SUBJECT: Timothy Neetz
Development Permit / 42079 Yarrow Central Road DATE: September 18, 2023

STAFF REPORT ON DEVELOPMENT PERMIT DP001628

DEVELOPMENT PERMIT NO. DP001741, 2023

Site Plan

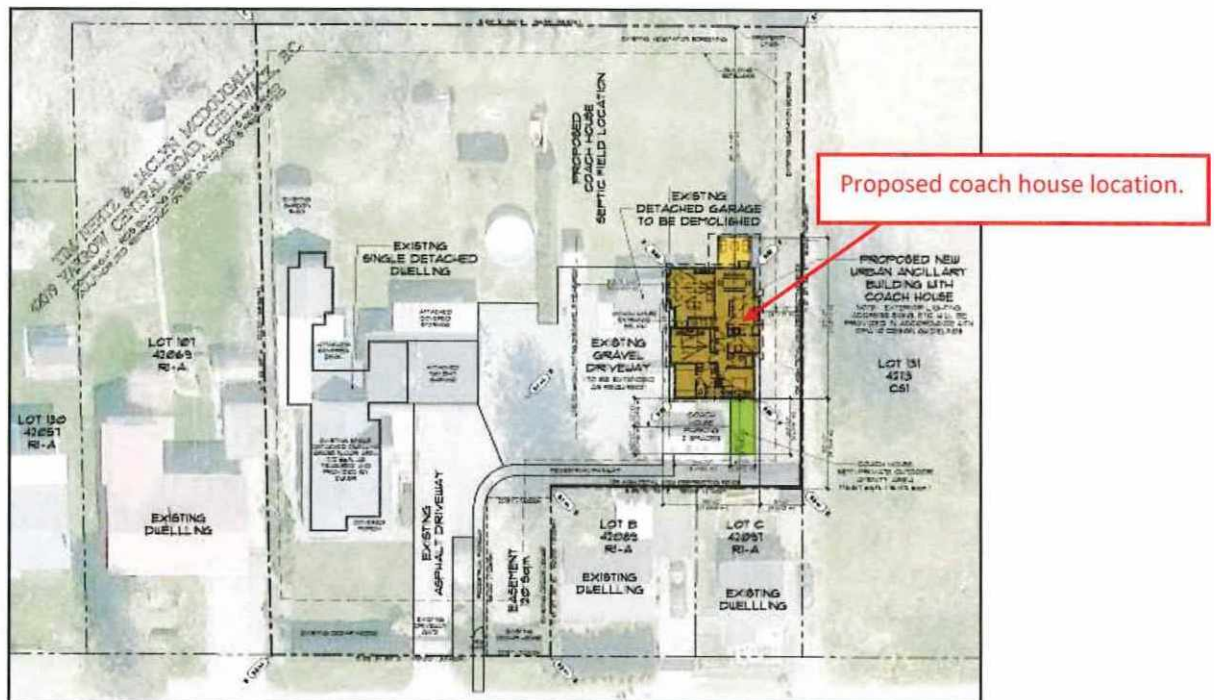
The subject property is approximately 3611m² in area and contains a single detached dwelling with an attached two bay garage and a detached garage, to be demolished pending coach house approval. As shown in the conceptual site plan below, the coach house is proposed to be sited adjacent to the existing single detached dwelling due to a unique lot orientation. As a result, the proposed coach house is sited along the south eastern corner of the property to the rear of two adjacent 250m² residential lots.

Proposed Elevations (as provided by the applicant)

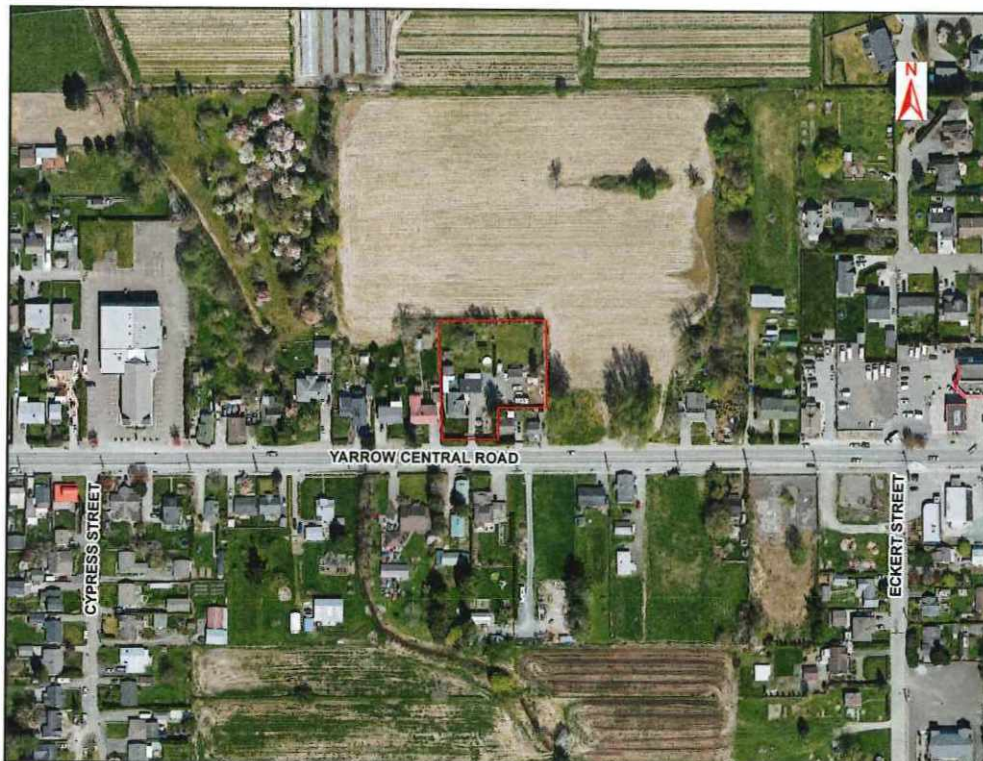
While all windows along the proposed southern elevation, adjacent to the single detached dwellings, are to be frosted, several windows along the east elevation, adjacent to a neighbouring agricultural property, are not. The applicant's rationale for this departure is that the non-frosted windows provide a view for future residents and overlook an agricultural parcel thereby limiting any possible impact to the privacy of the adjacent property. Staff consider the departure from the frosting requirement to be acceptable in this instance as the coach house is located more than 80m from the nearest house along the eastern elevation.

The proposed covered deck is oriented towards the agricultural property to the north rather than the principal dwelling to the west as required by the Design Guidelines. The applicant has proposed

this design to allow for open storage space beneath the deck without impacting access to the garage bays on the west elevation below. The deck orientation is considered acceptable in this instance due to the location of the coach house adjacent to an agricultural parcel which does not contain a residential use.

The proposed entrance foyer is 7.5m² (80ft²) in size, exceeding the 2m² maximum permitted under the DPA10 Design Guidelines. The applicant requests a larger foyer to provide space for a bench with coat hooks within the area beneath the stairs. Staff are not supportive of this departure from the Design Guideline as there is sufficient room within the coach house to accommodate a coat rack and bench upstairs while containing all rooms and services on the same floor. Further, the proposed building layout does not meet the intent of the definition of a coach house, as established under the Zoning Bylaw and endorsed by the Affordable Housing and Development Advisory Committee, which requires all services and rooms forming part of the dwelling unit to be located on a single storey. This definition was drafted in conjunction with the Design Guideline which restricts the foyer area to 2m² to ensure the residential space associated with coach houses is limited and clearly ancillary to the principal residence.

1.1	Coach houses shall be designed as a single-level apartment unit, with all services and rooms forming part of the unit located on the same floor.	No	A 7.5m ² foyer is proposed on the first storey with all other rooms on the storey above. Staff do not support this departure from Design Guidelines and recommend requiring a 2m ² foyer as a condition of the draft Development Permit

1.2	Coach houses accessed by an interior staircase shall meet setback requirements, be located within an entrance foyer with a maximum area of 2m ² and designed for exterior access only.	Partial	A proposed 7.5m ² foyer connected to an interior staircase provides direct access to the coach house from the exterior. Staff do not support this departure from Design Guideline requirements and recommend requiring a 2m ² foyer as a condition of the Development Permit

1.3	Use of frosting and/or clerestory windows on walls facing neighbouring properties.	Partial	Windows along the south elevation are frosted. Windows along the east elevation are not frosted. This departure from the Design Guidelines is considered supportable in this instance as the non-frosted windows face an agricultural property without a residential dwelling.

1.6	Balcony and/or deck is oriented towards principal dwelling and is less than 3.0m in height	Partial	The deck is oriented away from the principal dwelling facing north. This departure from Design Guidelines is considered supportable in this instance as the deck is less than 3m in height, located more than 20m from the rear lot line, adjacent to a property that does not contain a residential dwelling.

A.) Approve the application as proposed by the applicant subject to conditions, including a reduction to the size of the entrance foyer (Staff's Recommendation):

- ☐ That the entrance foyer be restricted to 2m² in size; and
